PL 2021-0009

Re: May Hunt Residence, 4 Arbor Rd.

DATE: JANUARY 6, 2022
TO: PLANNING AND COMMUNITY DESIGN COMMISSION
FROM: CARLOS TREJO, AICP
 DIRECTOR OF PLANNING AND COMMUNITY DEVELOPMENT
RE: 4 ARBOR ROAD
 PETITION FOR COMMUNITY DESIGN & CONCEPT STORMWATER
 MANAGEMENT PLAN REVIEW

DATE: DECEMBER 16, 2021
TO: PLANNING AND COMMUNITY DESIGN COMMISSION
FROM: CARLOS TREJO, AICP
DIRECTOR OF PLANNING AND COMMUNITY DEVELOPMENT
RE: 4 ARBOR ROAD
PETITION FOR COMMUNITY DESIGN & CONCEPT STORMWATER
MANAGEMENT PLAN REVIEW

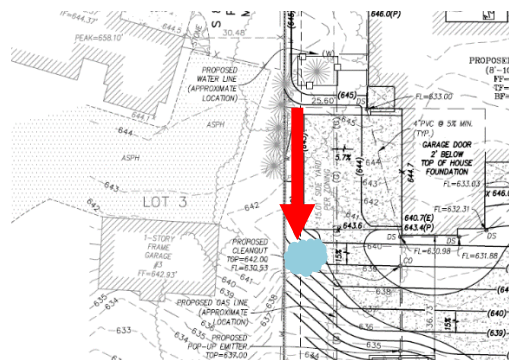
Subdivision approval. Correspondence was received this week from the Subdivision Association (attached). The Subdivision and the property owners have agreed to changes that deviate from the plans before the Commission. This includes the following:

- Relocation of the air conditioner and generator to the north side of the house.
- Additional masonry will be added to the side elevations.
- A berm (noted as existing) along the south property line.

On the berm, staff does not see one illustrated in the plan set. In addition, the conditions along the south of the driveway turnaround and the garage would not permit a berm being installed. The reason is that there is a swale and that swale needs to be maintained. (There is a series of pine trees illustrated along the property line, south of the driveway turnaround. Several of those are on the adjacent neighbor's lot, so they are not new nor can the City authorize their removal.)

Staff has no issues with the relocation of mechanical equipment and additional masonry and request the Commission support said changes and consider these as conditions of any action taken.

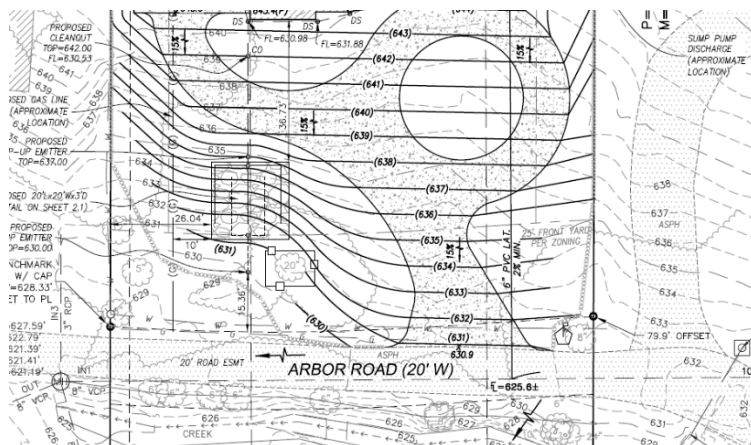
1. Driveway turnaround. The Site Plan illustrates a 5.7% slope from the garage doors to the south property line. Without any mediation on the hard surface of the driveway turnaround, surface stormwater is going to run directly to the neighbor's property. While the amount may be only the surface area, the acceleration and speed of stormwater going down a 5% slope is a concern.

The developer needs to redesign the southern edge of the turnaround to redirect stormwater from the surface area of the driveway turnaround to the street. The design needs to be cognizant that this recommendation may then direct acceleration and speed to the southeast corner of the driveway turnaround, causing erosion. Thus some form of BMP is recommended to impede the velocity of the water, and maybe even serve as a means to filter and hold the stormwater.

In addition, it is important to be noted that in staff's profession opinion there is not enough space between the driveway turnaround and south property line to design a berm.

- Provide a design solution to address the surface stormwater running south on the driveway turnaround. At a minimum, the redesign should include a defined edge on or adjacent to the driveway turnaround that redirects stormwater east towards the street. The release point of this design must include a BMP that will filter, disperse, and slow the velocity of the surface stormwater running off the driveway.
